**TELEDYNE CONTINENTAL<sup>®</sup> AIRCRAFT ENGINE**  
**CRITICAL SERVICE BULLETIN**  
 Compliance Necessary To Maintain Safety

**CSB96-5**  
 FAA APPROVED  
 SUPERSEDES M93-6.

**SUBJECT:** OIL PUMP DRIVE GEARS, P/N 649506 AND 649681

**FIGURE 1. OIL PUMP DRIVE GEAR**

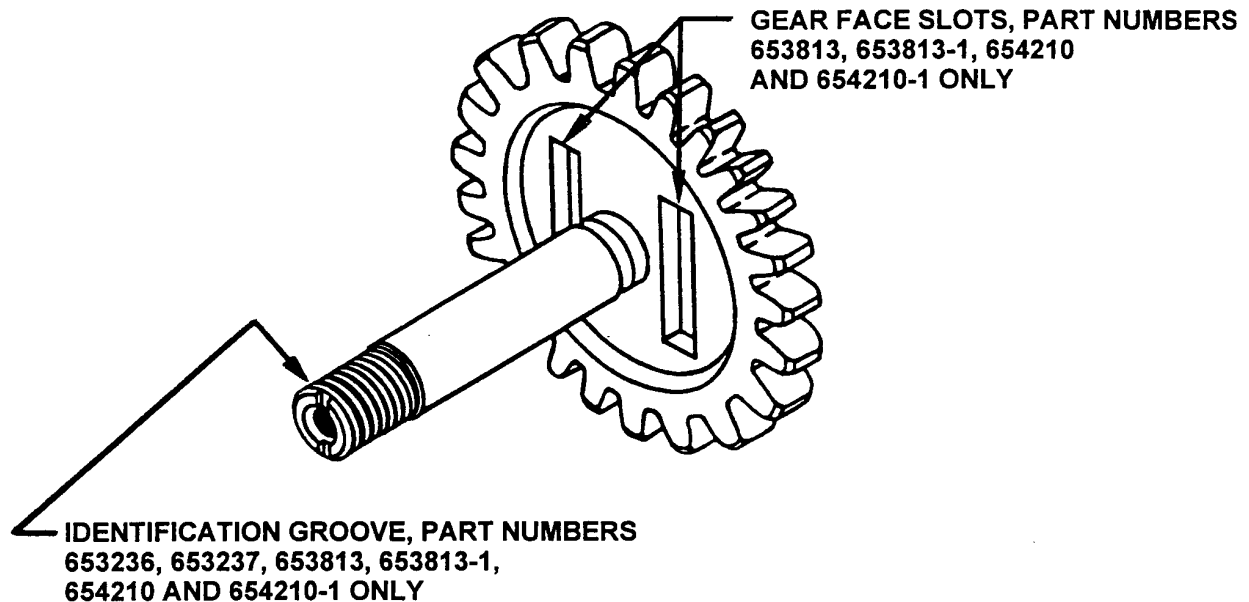
TCM requires that the subject gears be removed and replaced on all affected engines. The new oil pump drive gear part numbers are 654210 for right hand rotating engines and 654210-1 for left hand rotating engines. The new gear is identified by a groove across the threaded end of the shaft and two slots located in the gear face. See Figure 1 and NOTE 2. The part number 653236 and 653237 gears will only have the groove across the threaded end of the shaft.

The subject gears P/N 649506 and 649681 must be removed from service and replaced with the current part number gears as shown in Table 1.
